Panel Report

Yarra Planning Scheme Amendments C218 and C219

Rezoning of sites in Trenerry Crescent, Abbotsford

25 October 2017

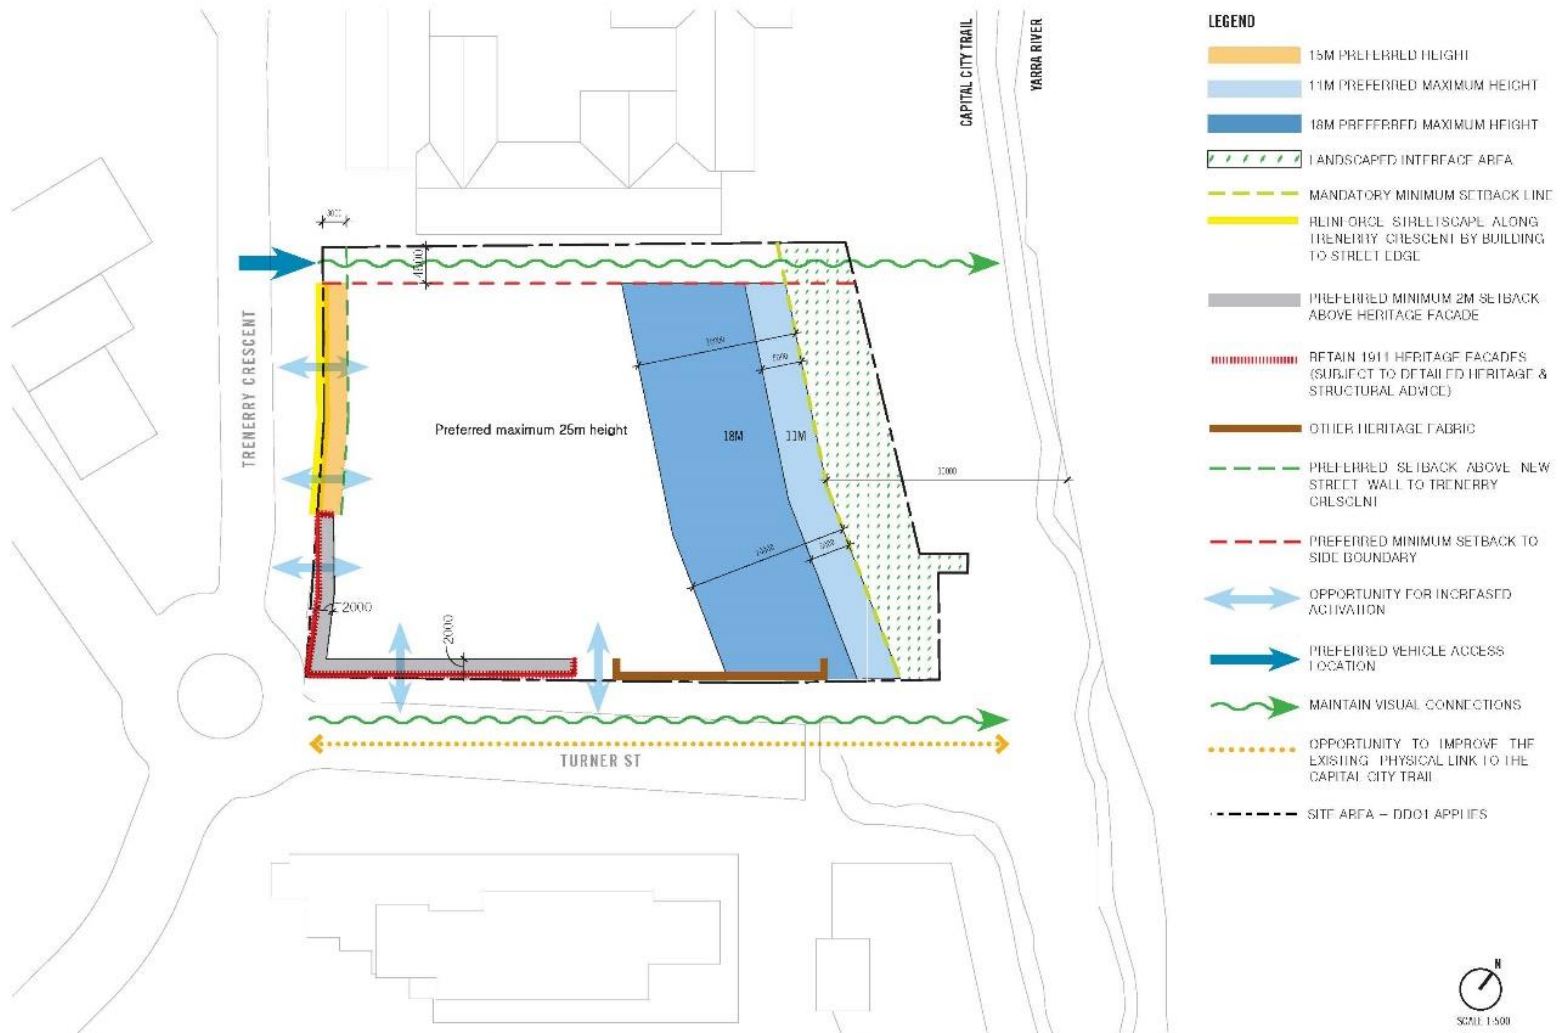
- Add a landscaped interface area to the Yarra River in the Incorporated Plan
 - Add an application requirement in the IPO requiring the design response to address the sensitive river corridor environs to minimise visual impacts

- A new requirement for the Incorporated Plan to show areas of landscaping to minimise visual intrusion of development in the Yarra River corridor
 - A new Development Principle on set back from the Yarra River interface to provide a transition in built form and minimise the visual prominence of development from the Yarra River.

- 5. Adopt the form of Incorporated Plan Overlay Schedule 2 as contained at Appendix C to improve form and content of the overlay and the Indicative Framework Plan.**
